कार्यालय वन संरक्षक, उत्तरी कुमाऊँ वृत्त, उत्तराखण्ड, अल्मोड़ा।

विषय :- धाला-न्याड़ी-भीताकोट मोटर मार्ग निर्माण (प्रस्ताव सं० 9401/2015)।

विषय थाला-भ्याड़ी-भीताकोट मोटर मार्ग निर्माण (प्रस्ताव सं० 9401/2015)

विषय :- जनपद अल्मोड़ा में थला भ्याड़ी से भीताकोट मोटर मार्ग का निर्माण।(प्रस्ताव संख्या-9401/2015)

मालाकाट हादर मार्ग (लम्बाई-16.2 किमी)

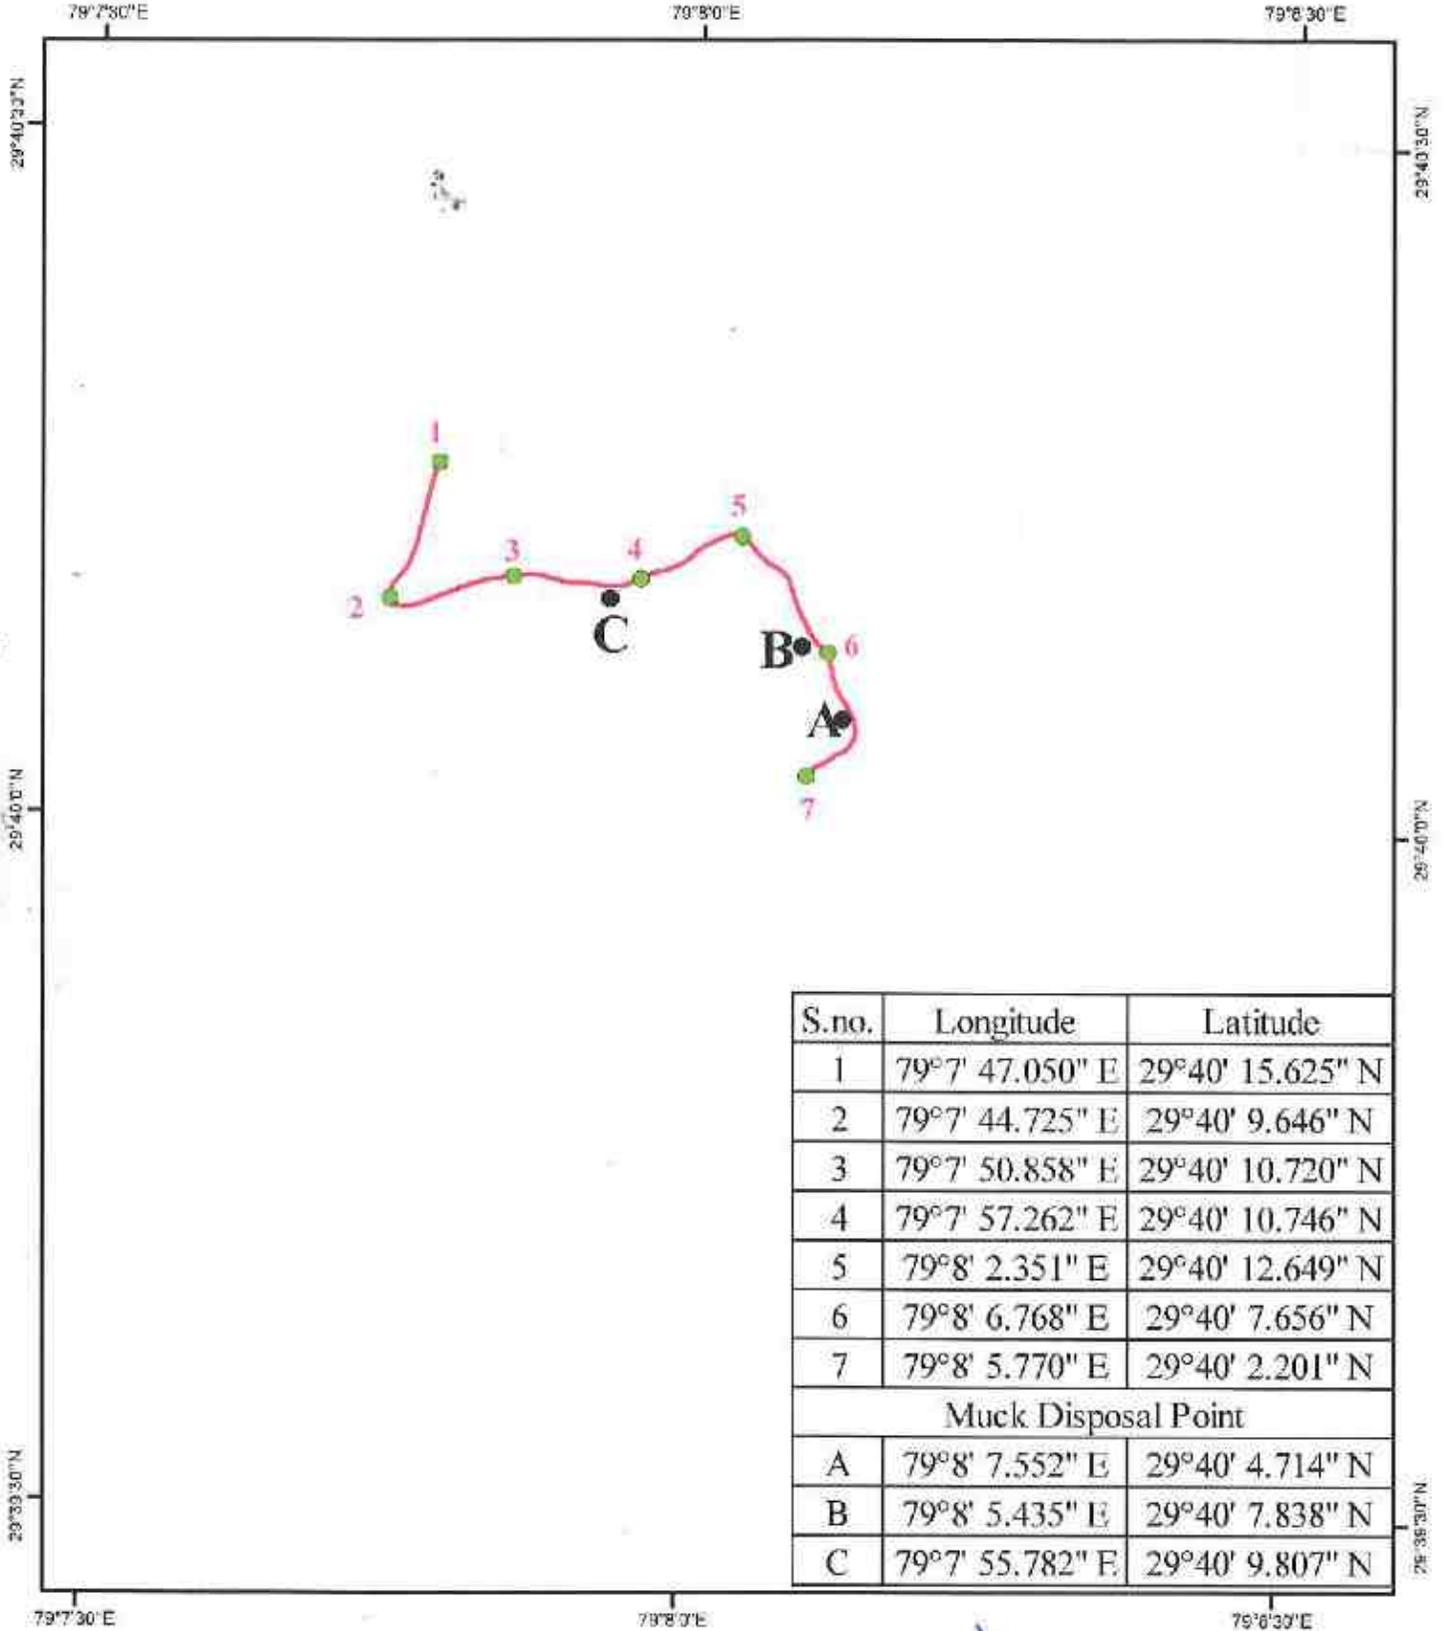
5.	In the geo referenced digital map of the area proposed for diversion uploaded at C (iv) Part I online the geo coordinates have been shown at very few points. May provide upload scanned copy of GIS software generated geo referenced digital map showing geo coordinates at 200 to 300 m interval along the alignment of the porposed mad including all turning points.	Geo referenced digital map showing coordinates of regular interval at 200m including all turning point along the alignment of the road attached at C (iv) Part I.

भीताकोट मोटर मार्ग हेतु चयनित क्षतिपूरक वृक्षारोपण स्थल

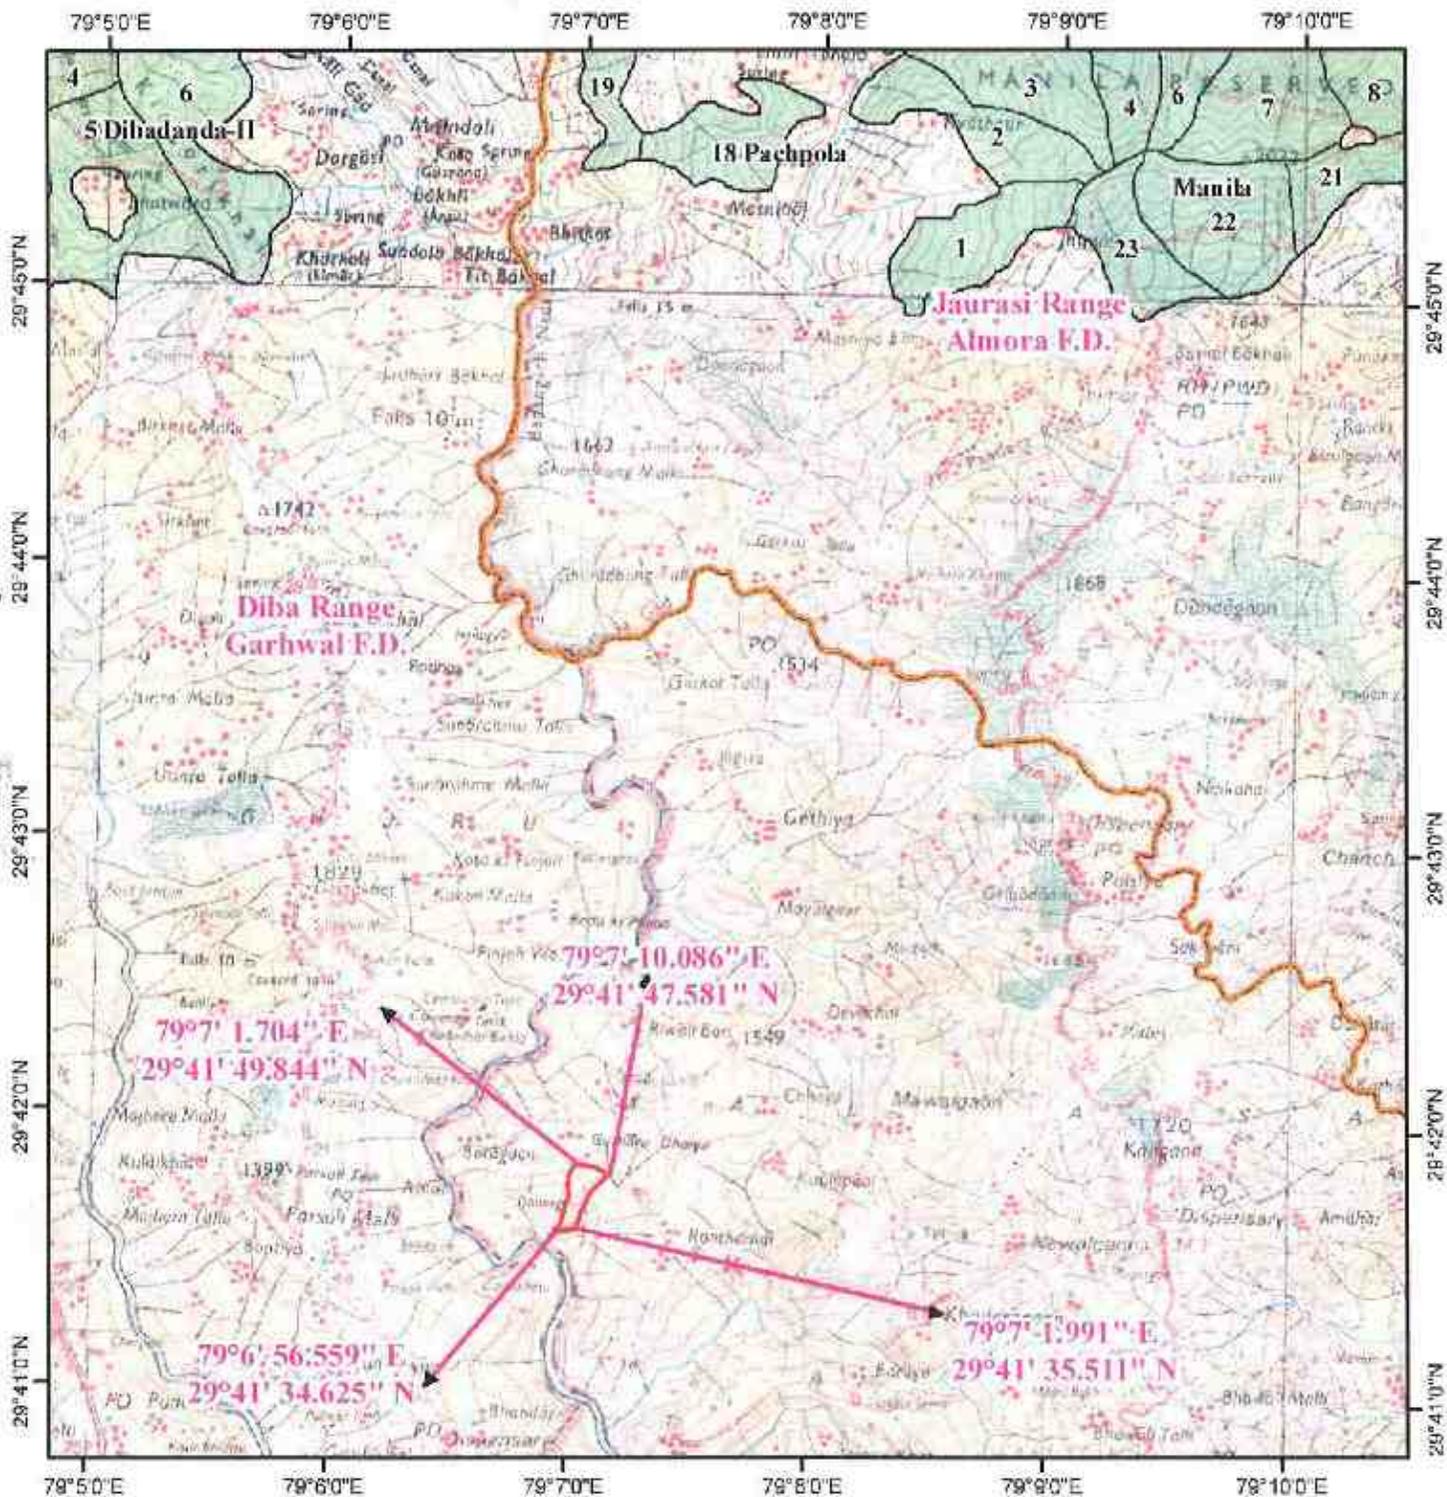
8.	Scanned copy of geo refereced digital map fo CA at para-L(v) is provided on google earth image which does not serve any pupose. In addition geo coordinate of one point only is shown in this map. May provide/ upload GIS software generated geo referenced digital map of the area proposed for CA providing geo coordinates at all corner points in shape (polygon/closed area) file.	GIS software generated geo referenced digital map of the area proposed for CA providing geo coordinates at all corner points in shape (polygon/closed area) file uploaded at para-L(v).
